METROPOLITAN GOVERNMENT OF NASHVILLE AND DAVIDSON COUNTY

STAFF RECOMMENDATION
407 South 14th Street
March 18, 2015

Application: New construction-infill
District: Lockeland Springs-East End Neighborhood Conservation Zoning Overlay
Council District: 06
Map and Parcel Number: 08313035500
Applicant: Robert Thompson, Pfeffer-Torode Architecture
Project Lead: Paul Hoffman, paul.hoffman@nashville.gov

<p>Description of Project: Construction of a single-family residence on this vacant interior lot.</p> <p>Recommendation Summary: Staff recommends approval with the conditions:</p> <ol style="list-style-type: none">1. The finished floor height shall be consistent with the finished floor heights of the adjacent historic houses, to be verified by MHZC staff in the field;2. Staff approve the final details, dimensions and materials of windows and doors prior to purchase and installation. <p>Meeting these conditions, Staff finds that the application meets the design guidelines for the Lockeland Springs-East End Neighborhood Conservation Overlay.</p>	<p>Attachments A: Photographs B: Site Plan C: Elevations</p>
--	--

1 SITE / ROOF PLAN
 SCALE 1/16" = 1'-0"

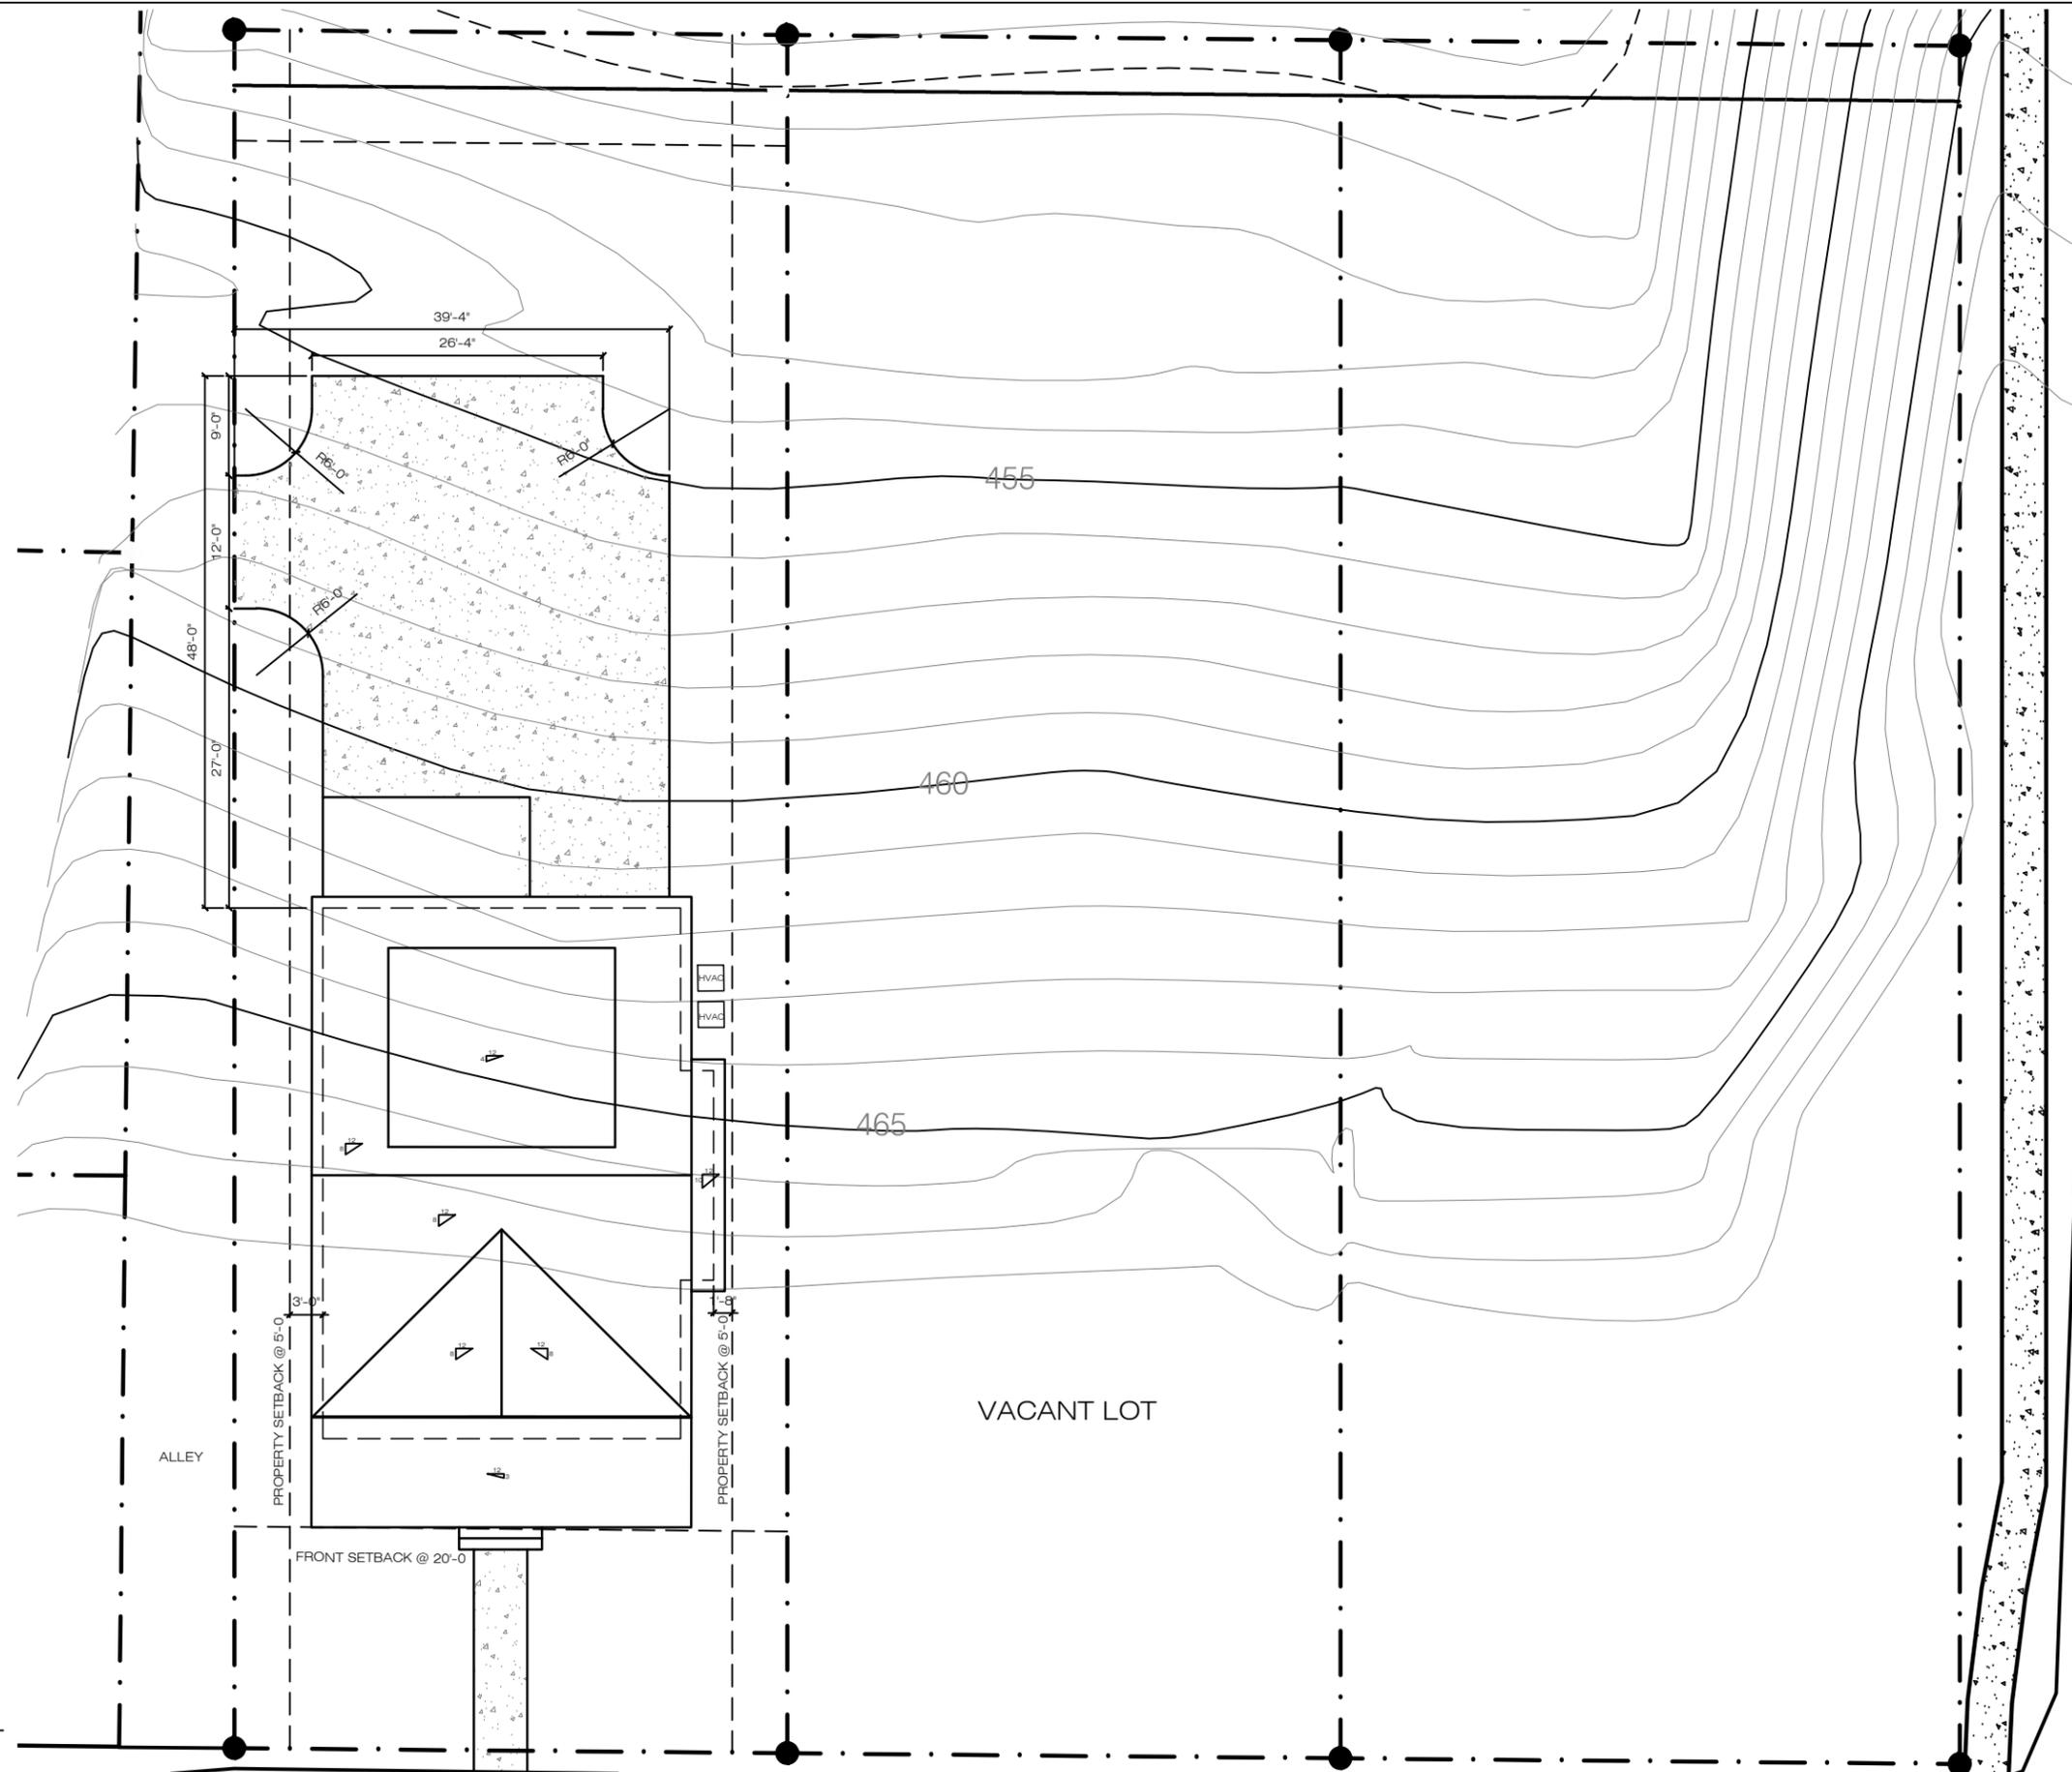
The building will have a front setback of twenty feet (20'). The adjacent properties are a vacant lot to the right, and across the alley, a contributing home oriented to Boscobel Street. The latter building is only five feet (5') from South 14th Street. The proposed twenty feet (20') is in keeping with the established street setback from the only other house facing the street on this block, and with other contributing houses farther down the street. The side setbacks will be eight feet (8') on the left and six feet (6') on the right. It will be sixty feet (60') from the rear property line. Staff finds that the project will meet guideline II.B.1.3.

The new structure will be aligned with its front elevation parallel to South 14th Street. A concrete walkway will connect the front porch to the street. Vehicular access will be via the alley. Staff finds that the orientation of the building will meet guideline II.B.6.

The HVAC units are proposed to be located at the rear corner of the house's right side; the location meets section II.B.9.
